**Reynolds Metals Company, LLC**  
**St. Lawrence Reduction Plant**  
194 County Route 45  
P.O. Box 500  
Massena, NY 13662 USA

**SUBJECT:** Response to Comments on the Self Implementing Plan (SIP) for PCB Remediation Buildings 722A (Pitch Pump House), 735 (Channel Press Building) and 722 (Paste Plant) Reynolds Metals Company LLC, Massena NY

This letter contains responses to comments received from New York State Department of Environmental Conservation (NYSDEC), Division of Environmental Remediation (DER) and Division of Water (DOW) on the Remediation Plan (Plan) for PCB impacts at three building areas located in the North Yard of the former Reynolds Metal Company LLC (RMC) St. Lawrence Reduction Plant located at 194 County Road 45 in Massena, New York ("Site").

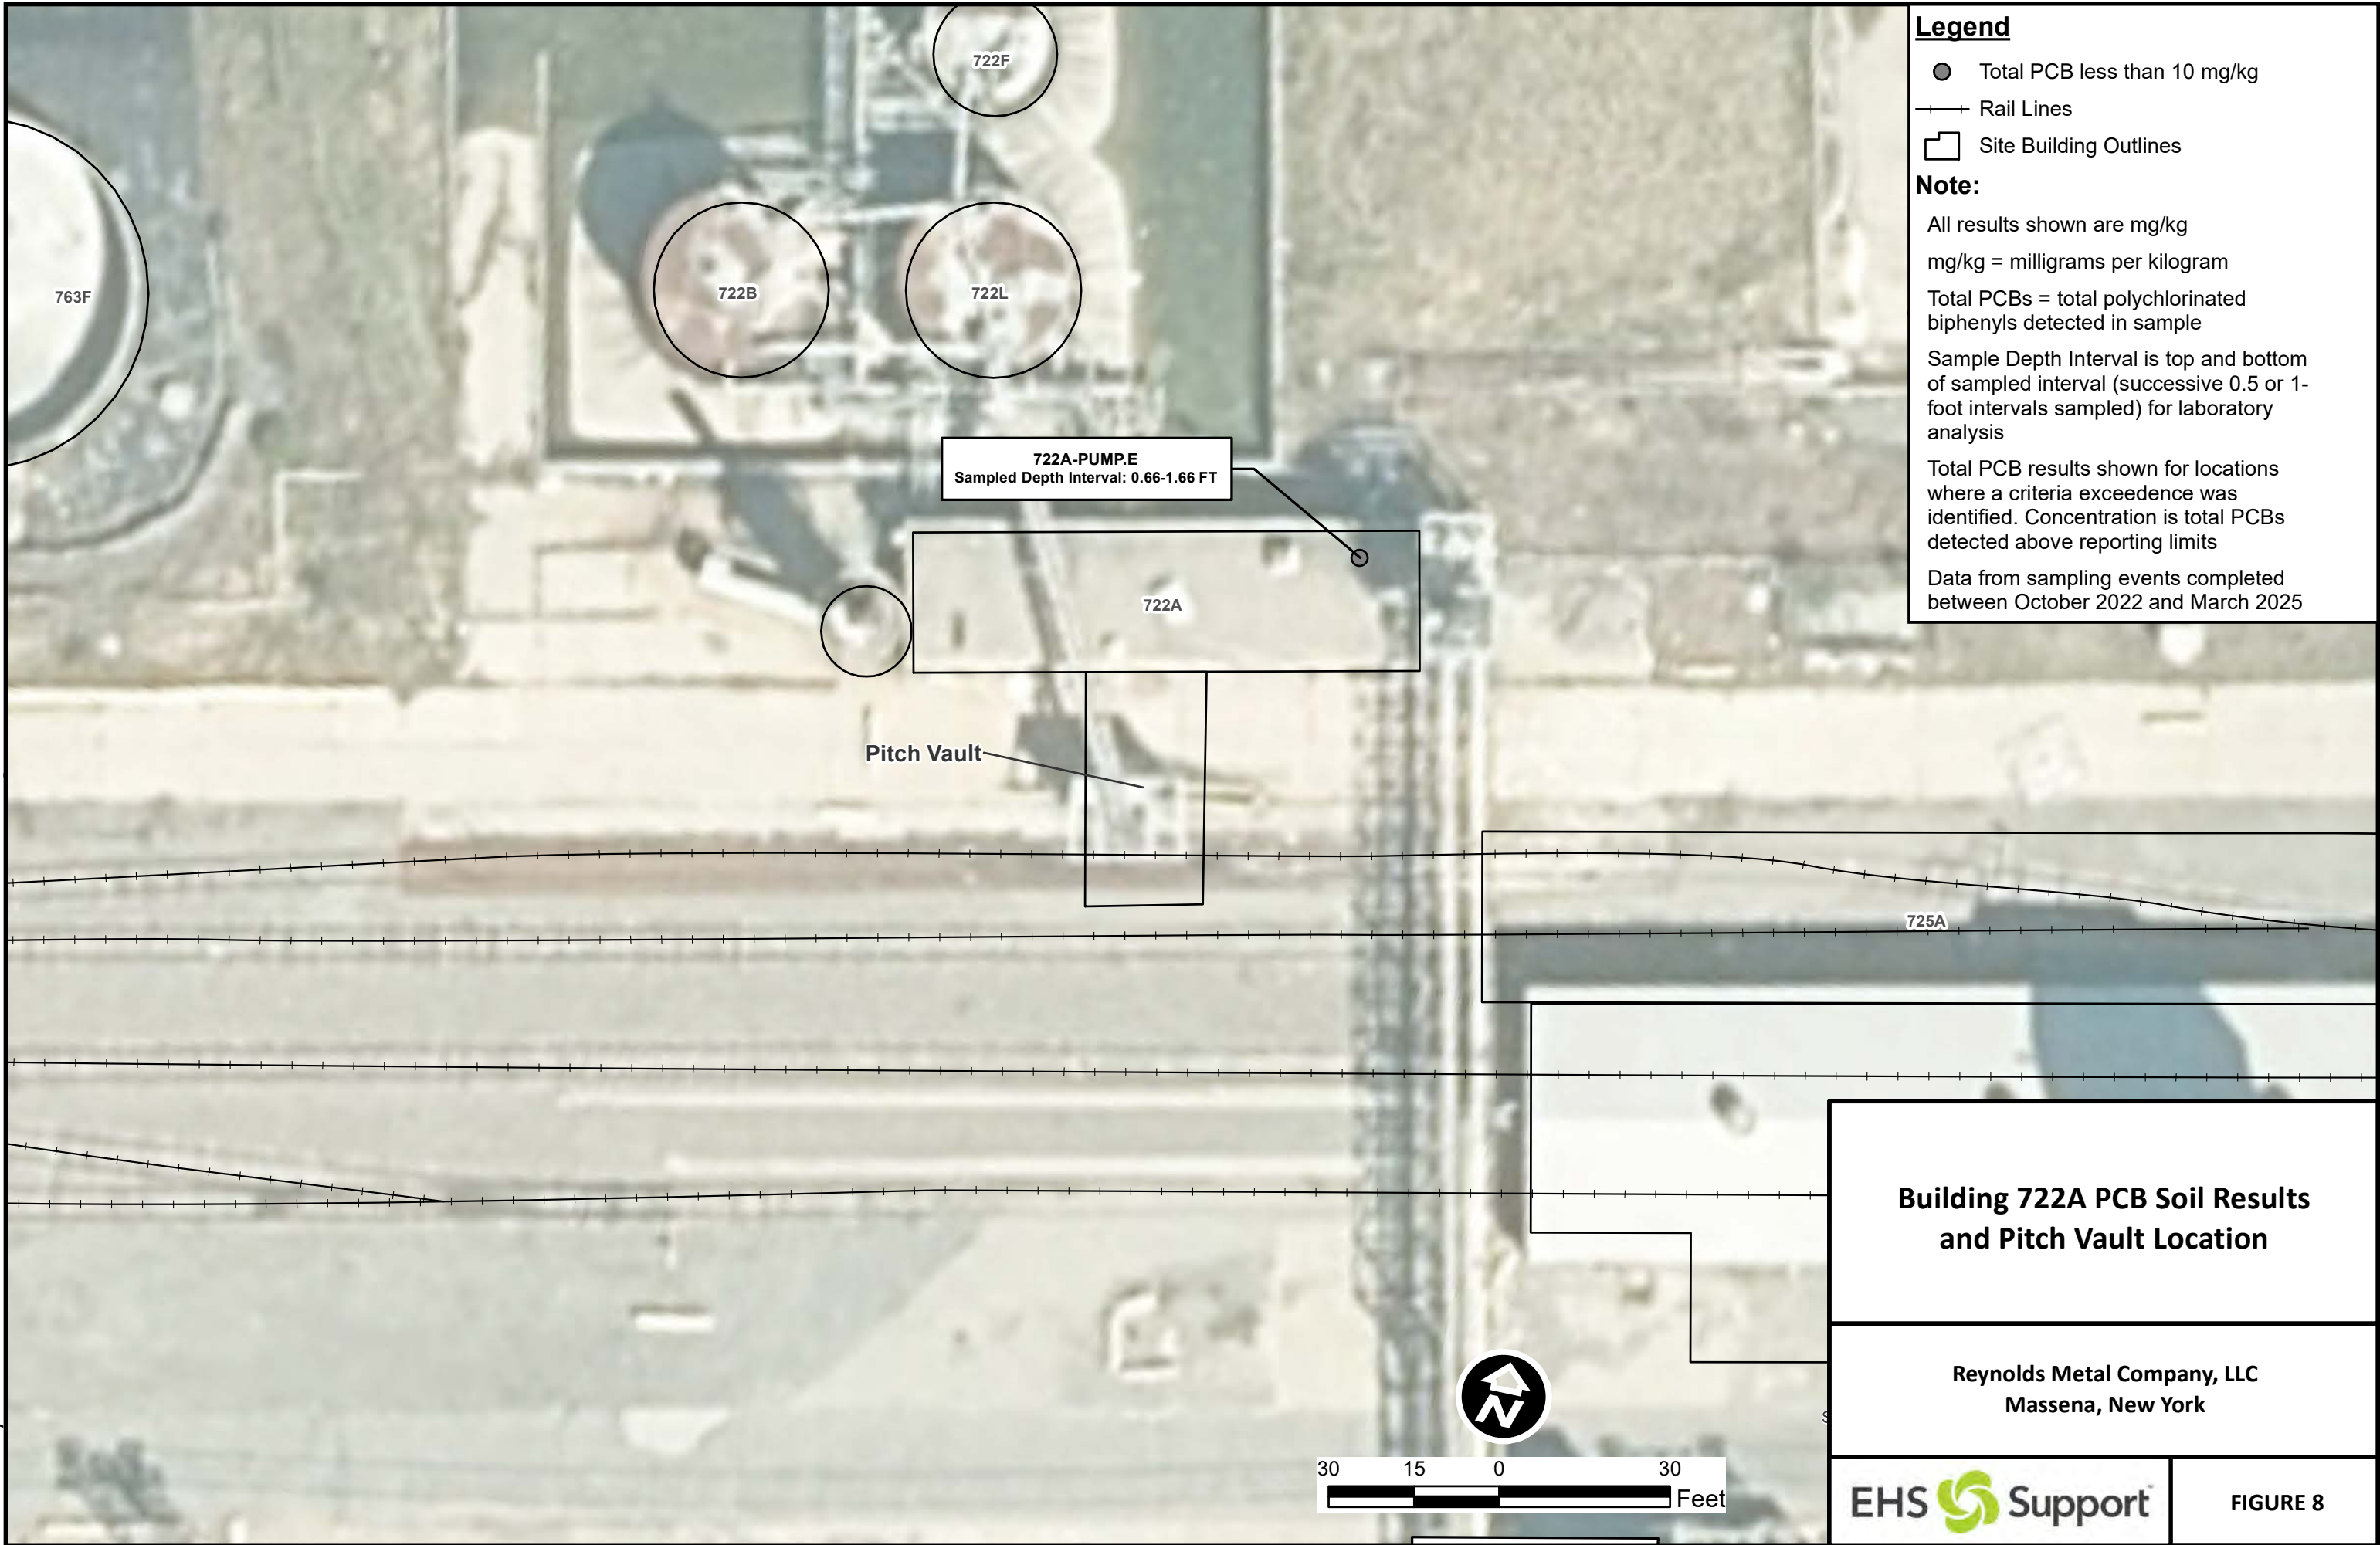
1. Section 2.2.2.1 Excavation Area (p. 12) – Beneath building 722 is an area identified as having PCBs greater than 10 ppm at depth. The Department acknowledges the constraints of the building footers but requests that as much soil be safely removed from the area outlined in orange from Figure 7.

RMC Response: As discussed above, the remediation for building 722 will not happen in 2025. Instead, additional characterization will be conducted to determine the impacts of PCBs at depth and the appropriate remedial pathway.

5. Figure 7, Note 1 – Provided this site is zoned industrial, the necessary backfill requirements for industrial use sites per Part 375 is as follows “for industrial use sites, use the lower of the protection of groundwater or the protection of public health soil cleanup objectives for commercial use as set forth in Table 375-6.8(b).”

RMC Response: Acknowledged. Imported backfill will be sampled to ensure it meets the standards in DER 10 section 5.4 and DER-10 Appendix 5.
